Docket Item # 6  
BAR CASE # 2009-0048

BAR Meeting  
April 15, 2009

**ISSUE:** Alterations to previously approved plans

**LOCATION:** 725 South Columbus Street

Figure 9. Proposed elevations

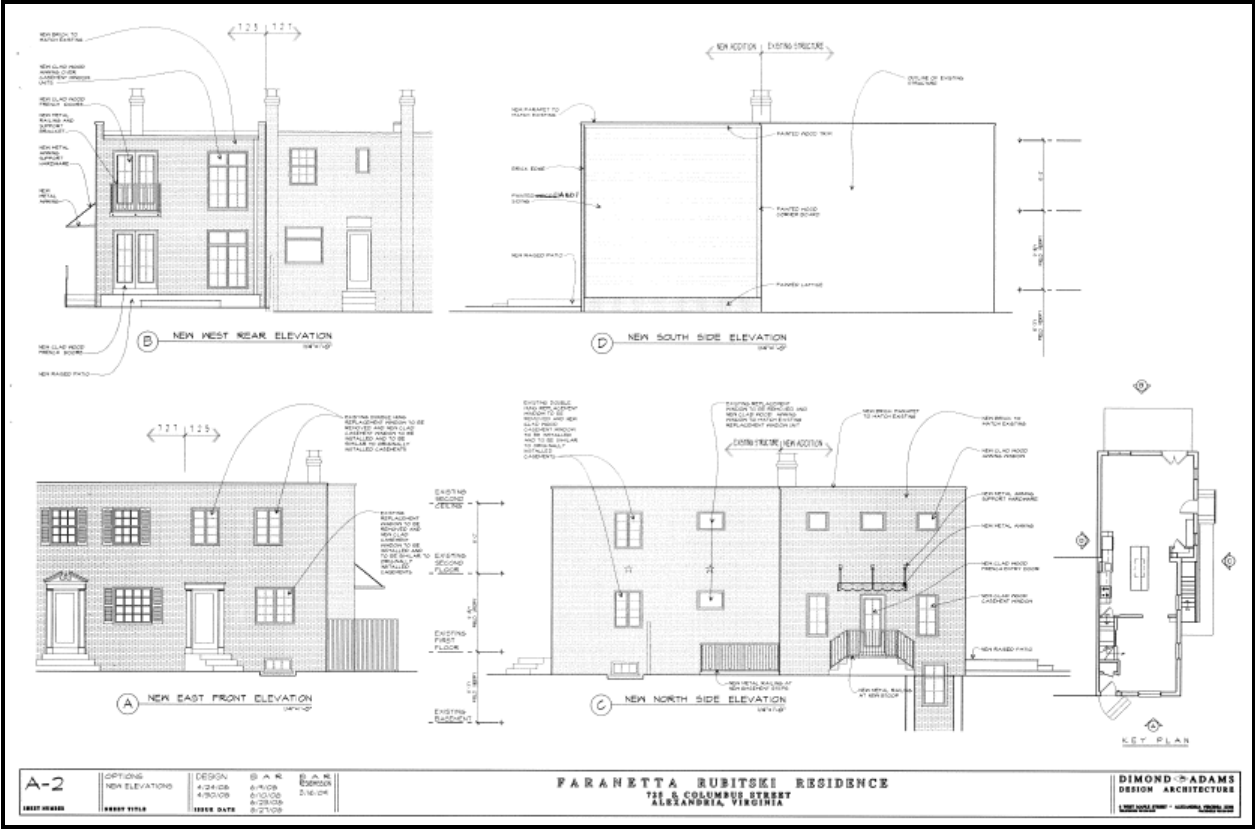
Instead of brick, the proposed south elevation will now be clad with Hardieplank siding with approximately 1 ½ feet of horizontal lattice at the base. The Hardieplank will be factory finished in a taupe color and the lattice will be painted to match. The wall will be constructed on the applicant's property and lifted into place.

At the basement level the applicant proposes to construct an egress window with an areaway. Only approximately 1 ½ feet of the multi-light casement window will be visible above grade. The areaway will be covered with an at-grade metal grate.

unfortunate, Staff finds this material change acceptable. The wall will be minimally, if at all, visible from the public right-of-way. However, Staff recommends that smooth fiber cement siding be used and that the nail holes not show in the installation of the siding.

Staff also supports the basement level window and areaway on the north elevation of the addition, which will not be visible from the public right-of-way.

1. That smooth fiber cement siding be used; and,
2. That the nails not show in the installation of the siding.
